## Certified Action Of the City of Raleigh Planning Commission

**Case File / Name:** IR-1-10 / Edwards Property

**SUBJECT:** IR-1-10 / Edwards Property

## Staff Report

IR-1-10 Edwards Property – recombination plan

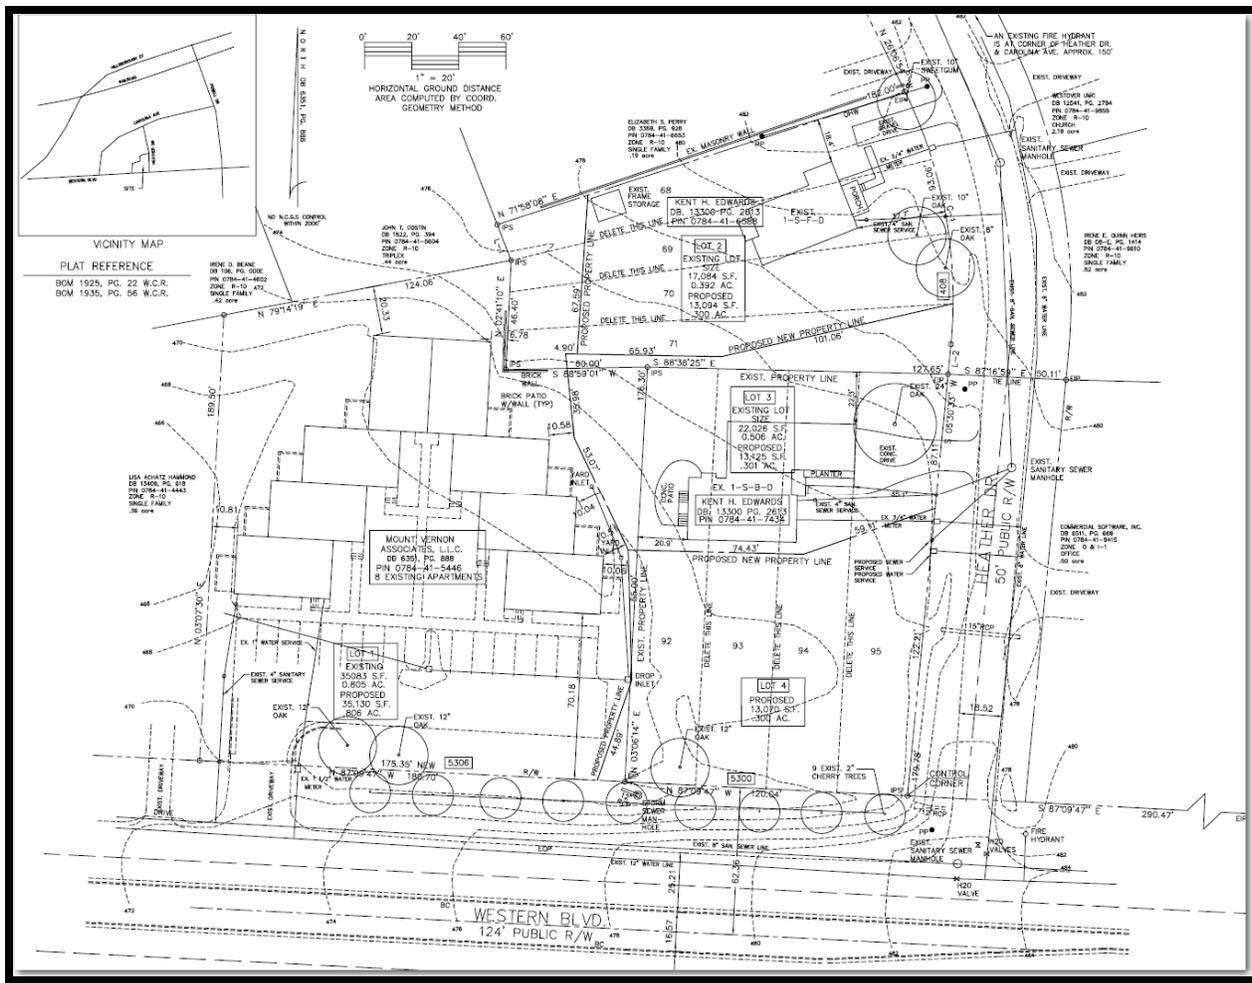
1. The lot lines are angled from the street in a similar manner as typical surrounding lots.
2. Lots consist of more than 4 lines as is typical of several of the surrounding lots. The existing lots prior to the recombination consisted of more than 4 lot lines.
3. The building envelopes for the proposed new lot(s) are placed in such a way that they are not one behind the other when viewed from the public street. Lots proposed may be adequately served by City services.

**Applicant response:** Lot lines for all lots are either perpendicular to the street or at a very narrow angle.

**Applicant response:** Some lots have more than 4 lines, but the original lot lines were greater than 4 lines.

**Applicant response:** All lots are configured to be side by side and facing the street

- (1) That the Planning Commission finds that this infill recombination meets the lot layout standards of Section 10-3032(d);

- (5) That the following note be shown on all maps for recording; Lot 4 will have no direct access onto Western Blvd;
